File Number	PL 21-144	Contact	Adam Fulton	
Type	Preliminary Plat	Planning Commission Date		September 28, 2021
Deadline for Action	Application Date	August 19, 2021	60 Days	October 18, 2021
	Date Extension Letter Mailed	Sept. 2, 2021	120 Days	December 17, 2021
Location of Subject	Northwest of intersection of Skyline Parkway and Hwy 2 (PIN 010-2741-01076)			
Applicant	Cynthia and Rick Crawford, owners	Contact	Available, on file	
Agent	Northland Consulting Engineers, SAS Landscape Architects, Alta Surveyors	Contact	Available, on file	
Legal Description	See Attached Map			
Site Visit Date	September 9, 2021	Sign Notice Date		September 14, 2021
Neighbor Letter Date	September 2, 2021	Number of Letters Sent		7

Proposal: Requested is approval of the preliminary plat of SUGARLOAF to provide for subdivision of the referenced 67.71 acre site for development of 13 rural residential lots in the RR-1 district. The proposal includes construction of a new public street.

PRELIMINARY PLAT OF SUGARLOAF

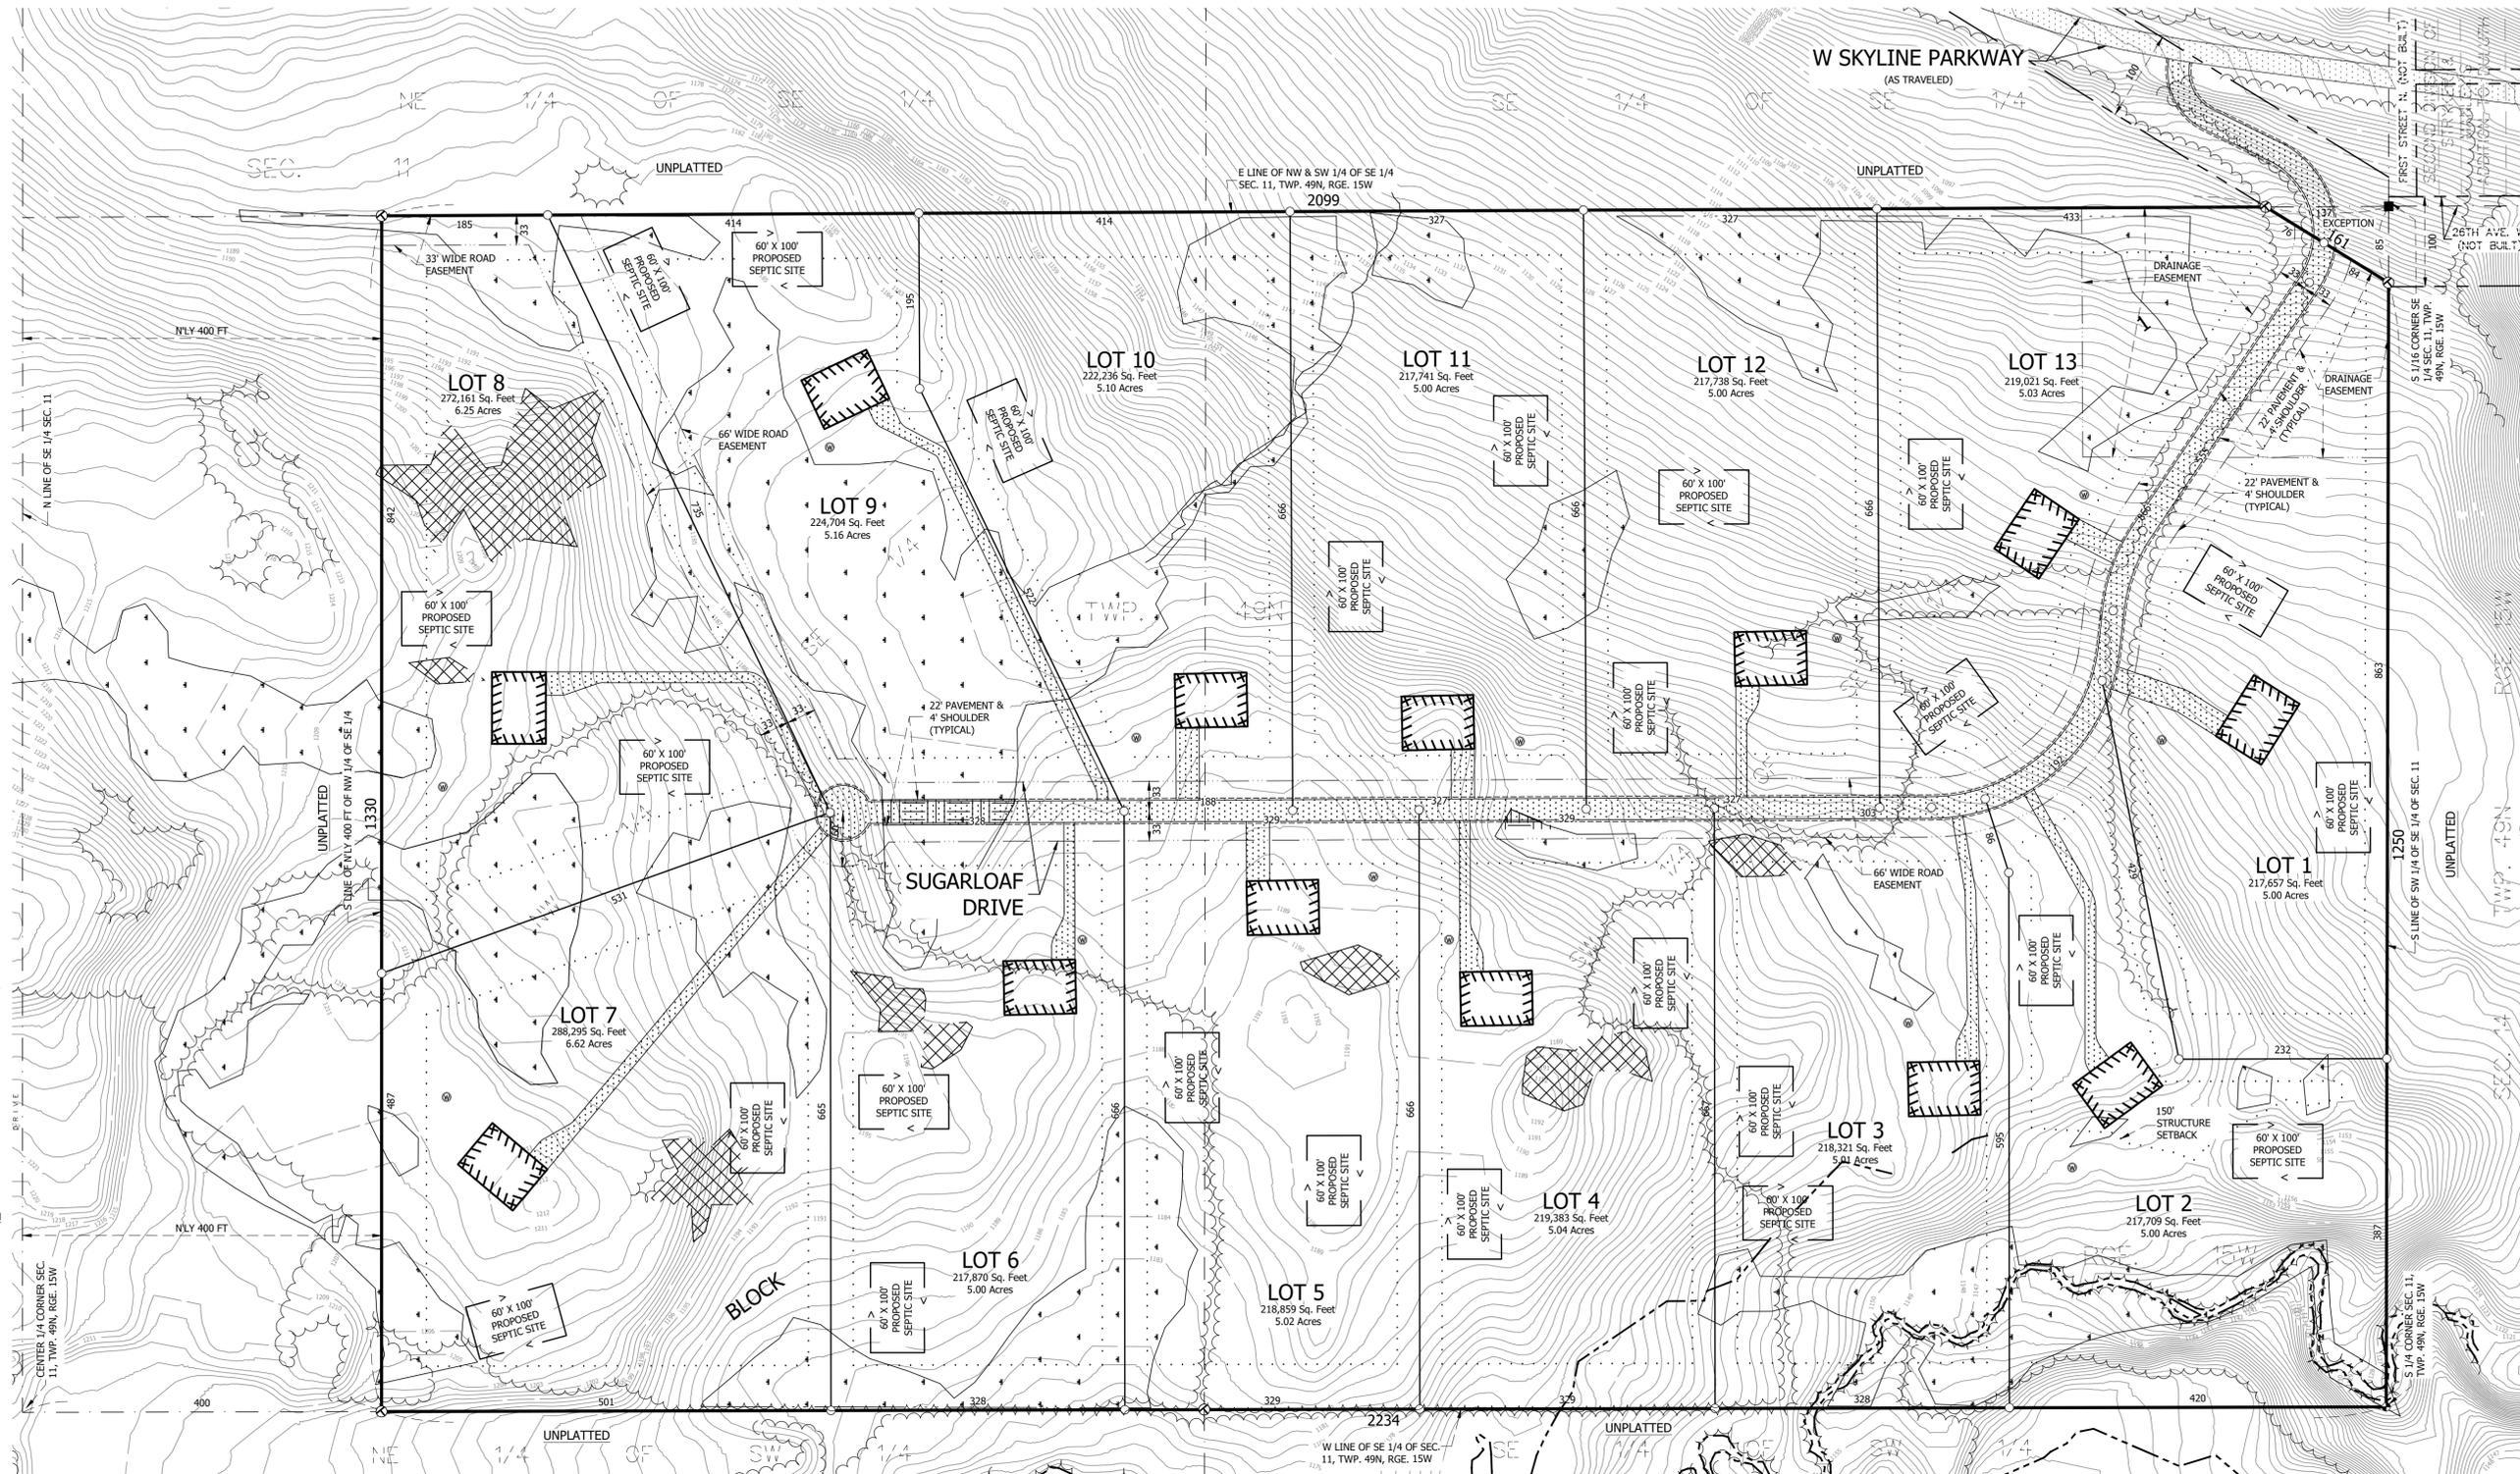
- 3) Site Plan. The site plan includes a depiction of the proposed thirteen lots to be created as part of the preliminary plat of “SUGARLOAF.” The preliminary plat appropriately identifies wetlands, proposed driveway locations, and proposed building envelopes for the 13 new houses. The plat also includes two potential locations for septic systems on each lot.

- 6) Wetlands. Wetland impacts are anticipated to result as an outcome of this development. A complete wetland delineation is on file. Conditions are included to require modifications to reduce avoidable wetland impacts on the final plat. Those conditions relate to modifications to driveway locations and reconsideration of site layouts on several lots.

- 7) Future connectivity. The proposed terminus of the cul-du-sac will end at the junction of Lots 7, 8, and 9. However, additional right-of-way is to be dedicated on the final plat to provide for access to the northeast, where a future development could potentially connect to the city's existing street grid in this location. At present, there is no access to those streets except across private property. Were that private property developed, the street network could be connected.

- a. The proposed driveway serving Lot 9 shall be relocated, either through modification to the lot line between Lot 9 and Lot 10, or through alternate means, to avoid wetland impacts resultant through construction of said driveway.

- b. Drainage and utility easements shall be provided consistent with UDC requirements for shoreland protections to ensure the preservation of natural vegetation near Kingsbury Creek along Lots 2 and 3. Permanent metallic markers on rigid metal posts shall be placed at the location of shoreland setbacks indicating that all natural vegetation between the permanent markers and the creek is to remain in a natural state.

- c. Drainage and utility easements shall be established over no less than 90% of the wetlands existing on Lot 9.
 - d. Stormwater ponds are currently depicted on Lots 1 and 13 on the submitted "Stormwater Concept Plan." All stormwater ponds shall be redesigned to be located fully outside wetland areas, including those wetlands on Lot 13.

- e. Drainage and utility easements shall be provided consistent with UDC requirements for shoreland protections for the drainage way between Lots 10 and 11, which provides for the uplands for creeks referenced in the stormwater plan. Permanent metallic markers on rigid metal posts shall be placed at the location of shoreland setbacks indicating that all natural vegetation between the permanent markers and the creek is to remain in a natural state.
